IAE Propulsion System NON-MODIFICATION SERVICE BULLETIN

Subject: Transmittal of Revision 2 to Service Bulletin Number V2500-NAC-78-0151

NACELLE - THRUST REVERSER – DOOR, LATCH ACCESS AND LOWER OUTBOARD TRACK
BEAM - MODIFICATION OF

V2500-NAC-78-0151

Lower Outboard Track Beam Door Land Inspection
Figure 1

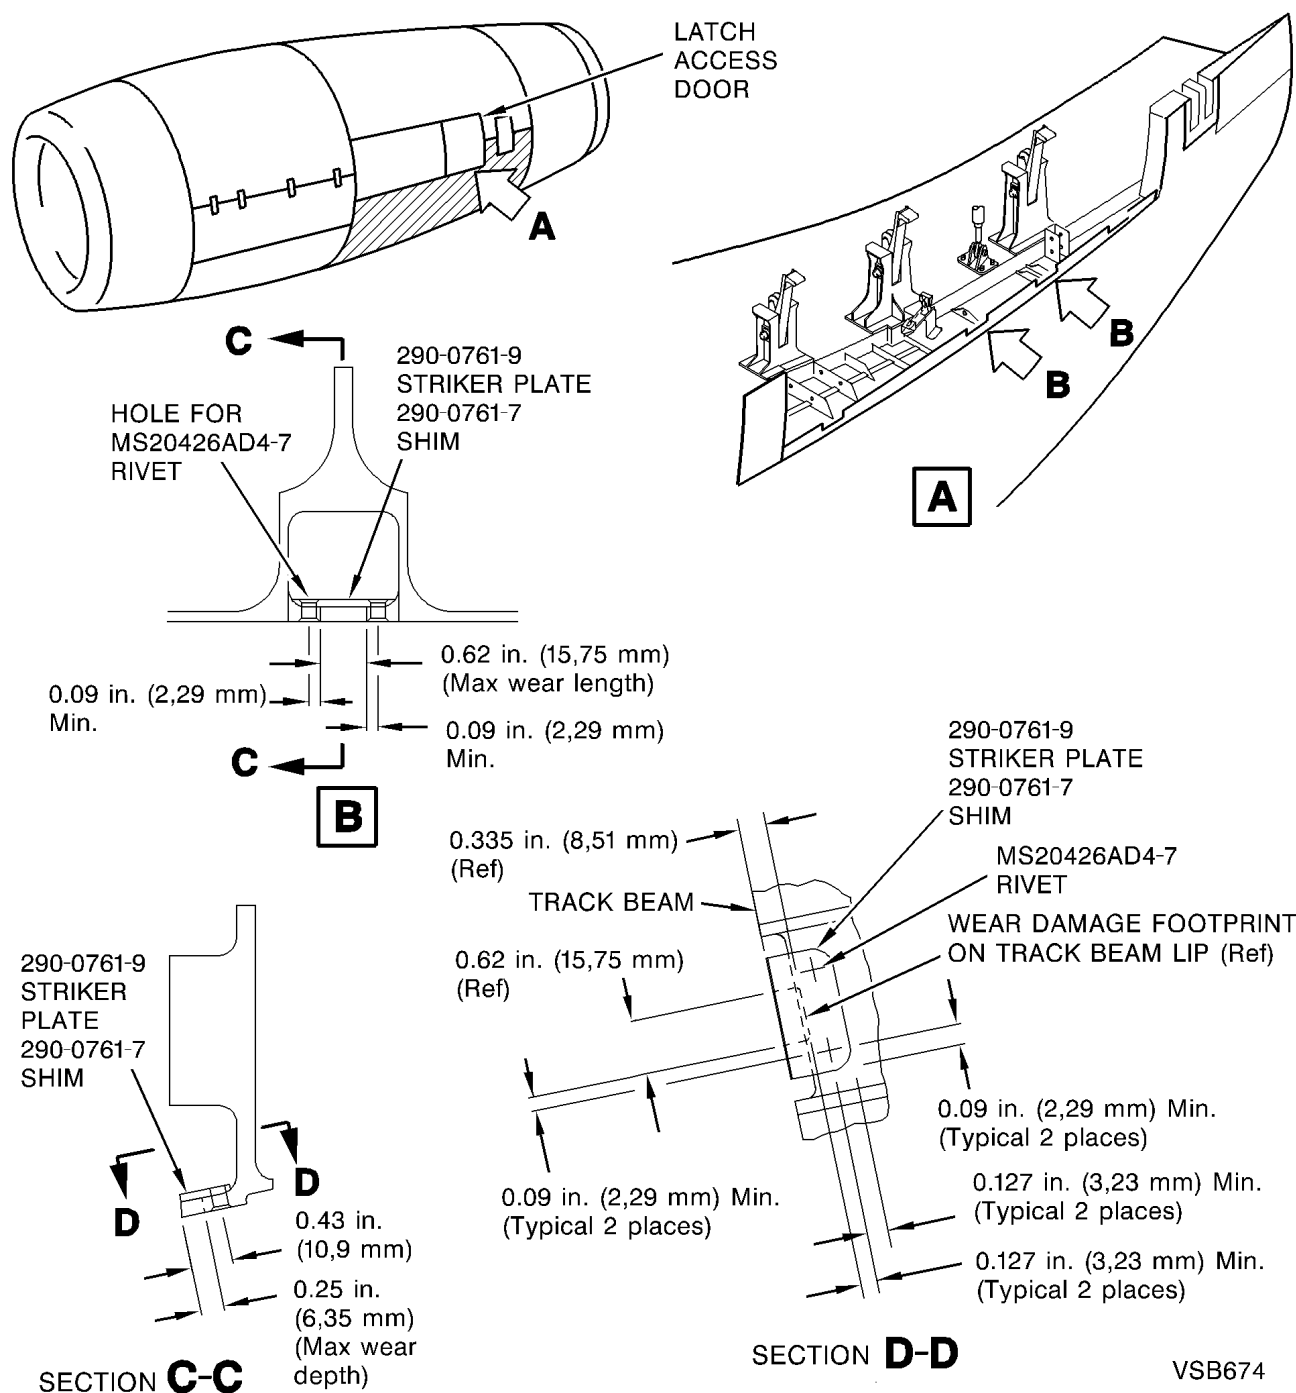
- (4) Clean the track beam in the area of the notches with solvent (CoMat 01-438) and a lint free cloth (02-099). Wipe the surfaces dry before the solvent becomes dry.
- (5) Examine the track beam in the area of the notches for damage. Refer to Figure 1.

- (a) If the damage is within the limits in Figure 1, you do not need to do service bulletin V2500-NAC-78-0175. Go to Paragraph 2.C.
- (b) If the damage is larger than the limits shown in Figure 1, you must do service bulletin V2500-NAC-78-0175 before you continue with this service bulletin.

Latch Access Door Latch Replacement and Seal Installation
Figure 2

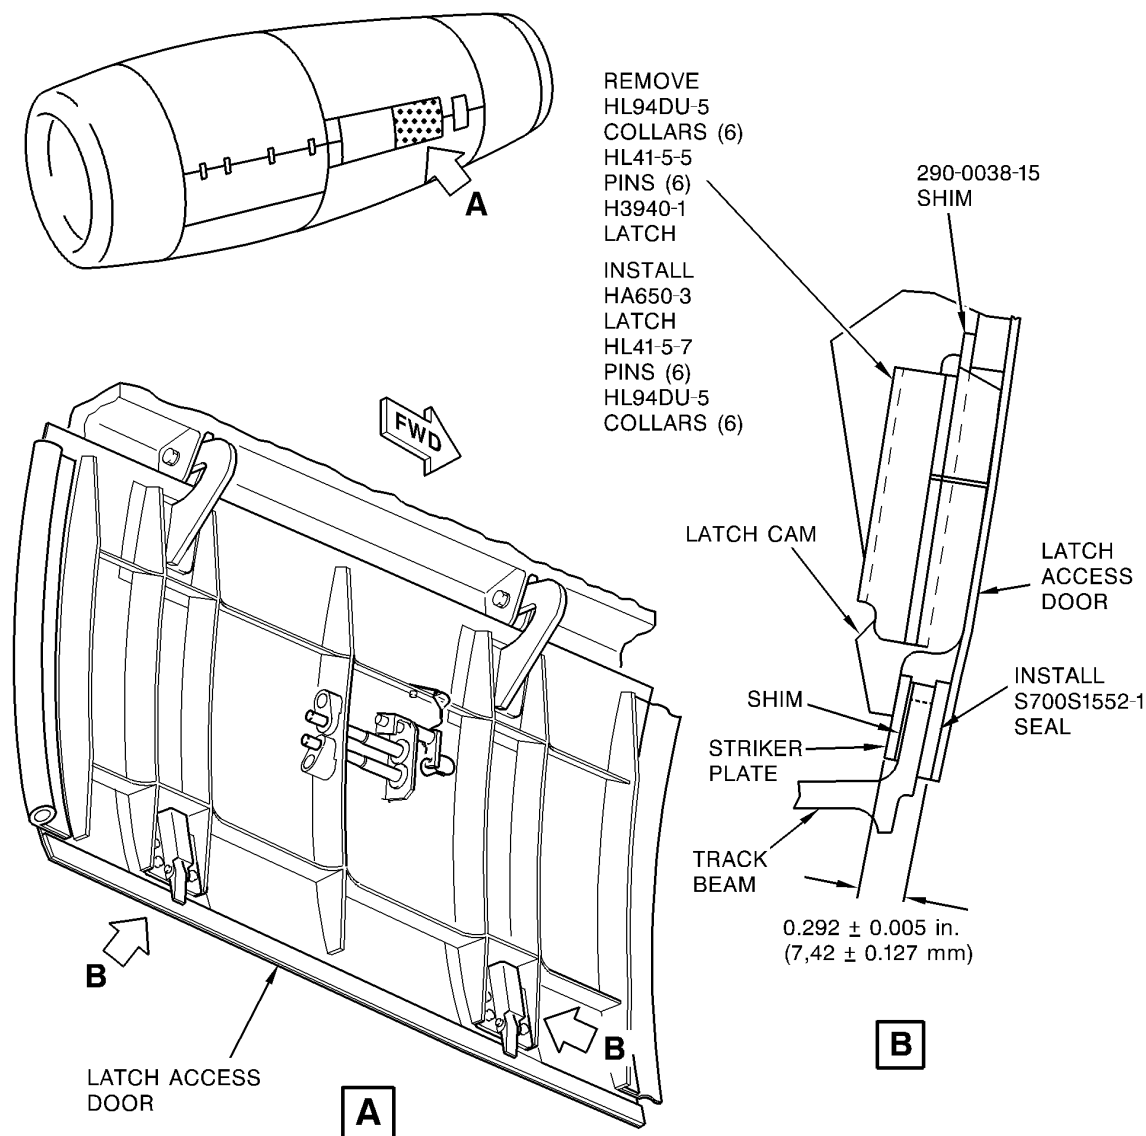
- (2) Remove the fasteners and latches from the latch access door. Refer to Figure 2.
- (3) Remove the seal from the lower edge of the latch access door.

- (9) Hold the shims and the latches on the pressure relief door assembly. Refer to Figure 2.
- (10) Measure and make a note of the distance between the latch access door latch cam and the inner surface of the latch access door. Remove the laminations from the shims as necessary to make the distance the same as shown in Figure 2.
- (11) Put the shims in place on the latch access door and back drill the fastener holes through the shims. Remove the burrs from the drilled holes.
- (12) Install the shims and latches on the latch access door with the fasteners. Wet install the fasteners with primer mix. Refer to Figure 2.
- (13) Clean the surface of the latch access door where the seal will be installed with a lint free cloth (CoMat 02-099) and solvent (CoMat 01-438). Wipe the surface dry before the solvent becomes dry.

Latch Access Door Track Beam Striker Plate Installation –
Thrust Reversers without Service Bulletin V2500-NAC-78-0175
Figure 3

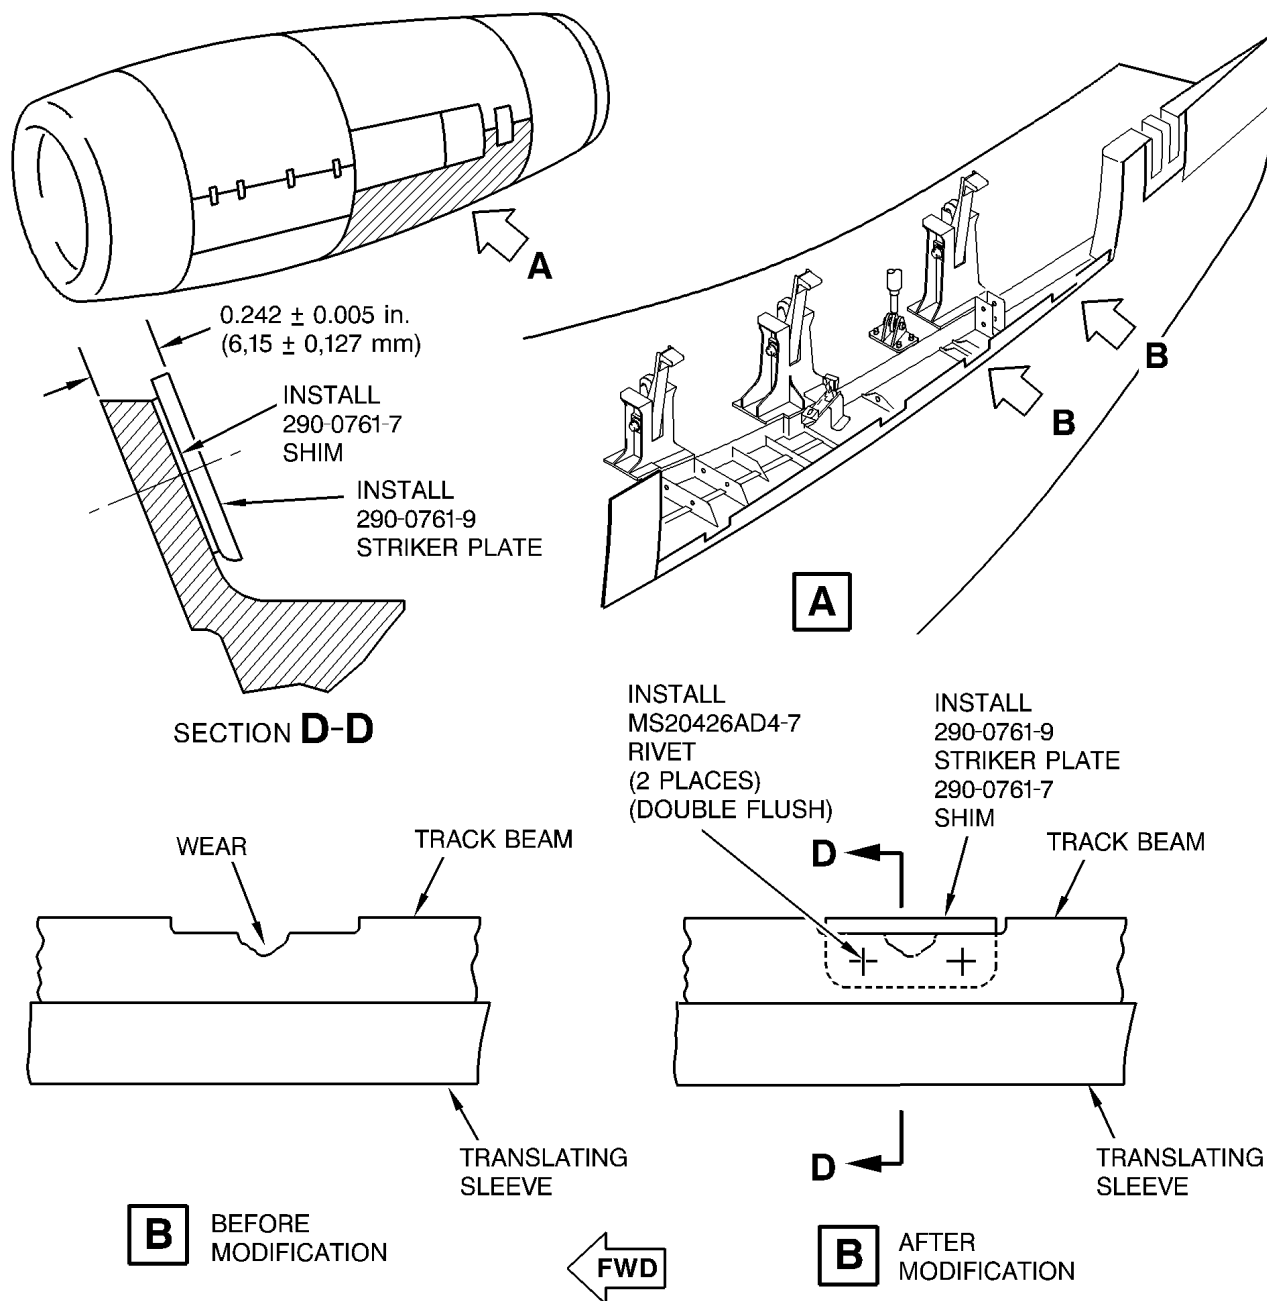
- (1) Find the notches on the lower outboard track assembly. Refer to Figure 3.
- (2) If necessary, at the forward notch, remove material from the heat shield to make space for the shim and striker plate.
- (a) Remove material from the heat shield to make space for the shim and striker plate.
- (b) Clean the edges of the modified heat shield areas with a lint free cloth (CoMat 02-099) and solvent (CoMat 01-438). Wipe the surfaces dry before the solvent becomes dry.

- (14) Cure the adhesive (CoMat 08-078). Refer to the manufacturer's instructions.
- (15) Make sure the distance between the outer surface of the track assembly and inboard surface of the striker plate is the same as shown in Figure 3 after you install the rivets. If necessary, remove material from the striker plate to get the proper dimension.

Latch Access Door Track Beam Striker Plate Installation –
Thrust Reversers with Service Bulletin V2500-NAC-78-0175
Figure 4

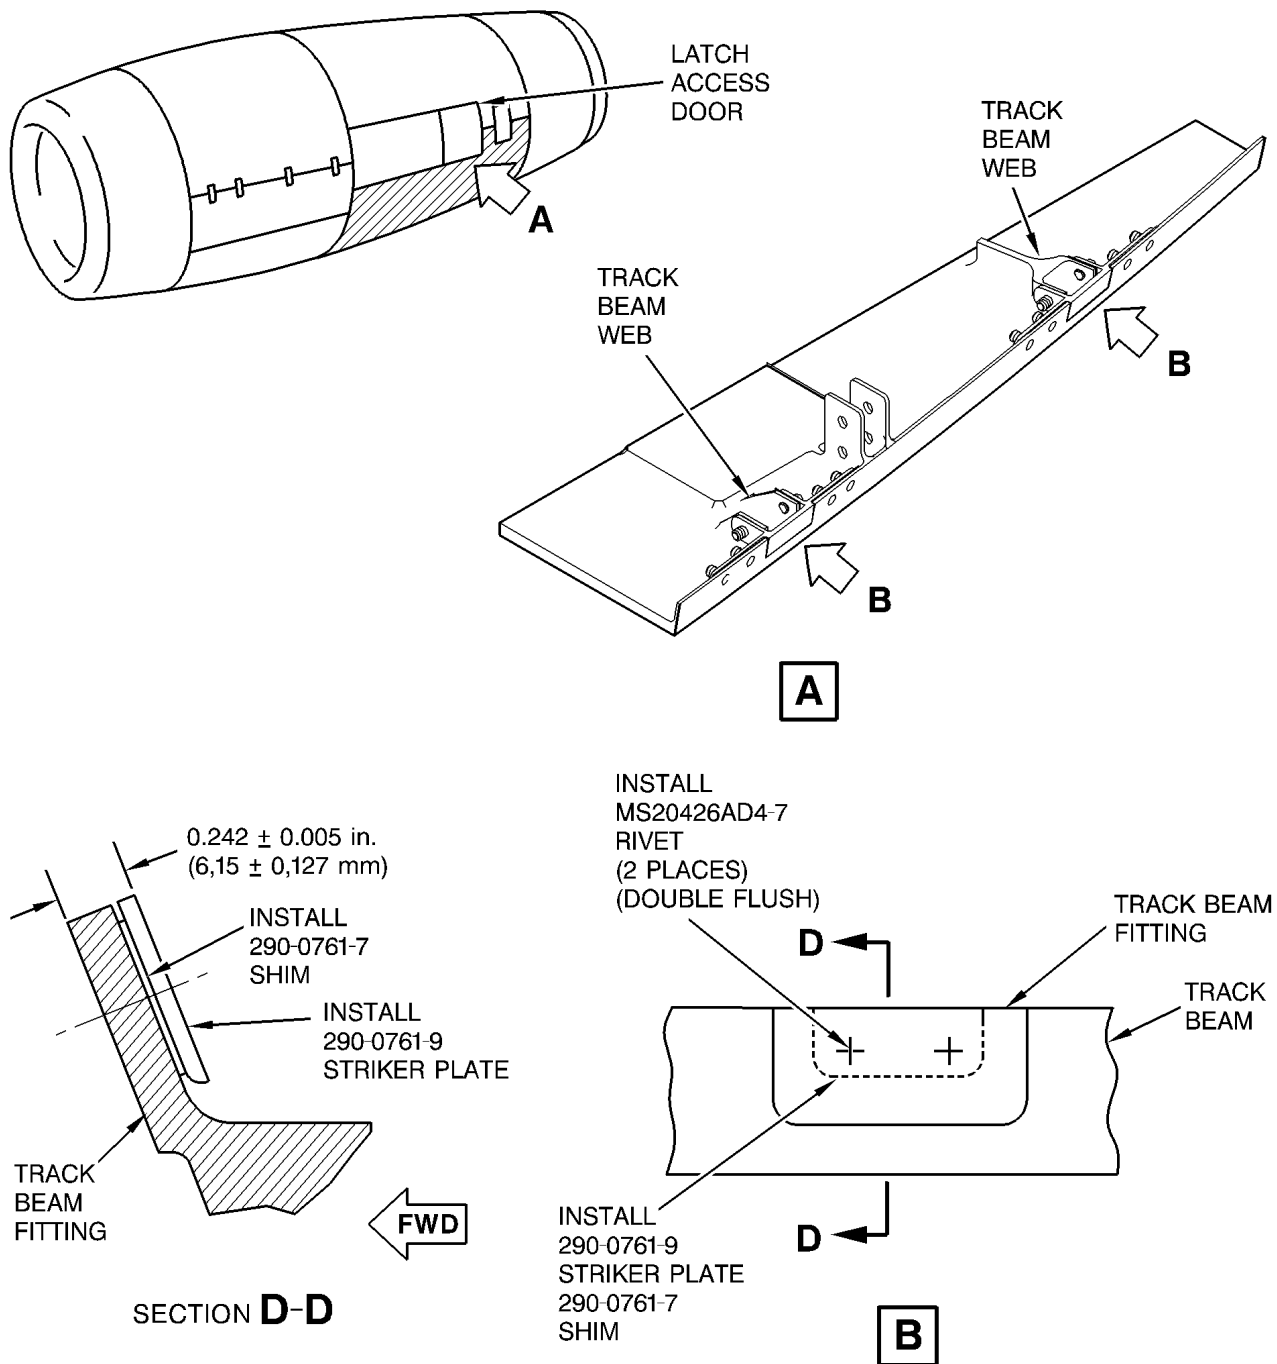
R (1) Hold the shims and latch access door striker plates on the lower outboard track assembly fitting
R as shown in Figure 4.

R (2) Measure and make a note of the distance between the outer surface of the track assembly
R fittings and the inboard surface of the striker plates. Remove laminations from the shims as
R necessary to make the distance the same as shown in Figure 4.

- R (10) Make sure the distance between the outer surface of the track assembly fittings and inboard
R surface of the striker plate is the same as shown in Figure 4 after you install the rivets. If
R necessary, remove material from the striker plate to get the proper dimension.
- R (11) Apply primer to both ends of the MS20426AD4-7 rivets installed on the lower outboard track
R assembly fitting.
- R (12) Cure the primer. Refer to the manufacturer's instructions.
- R (13) Make sure the latch access door opens and closes properly.
- R (14) Go to paragraph 2.G.
- R F. Post-requisite instructions
- R None.
- R G. Recording Instructions
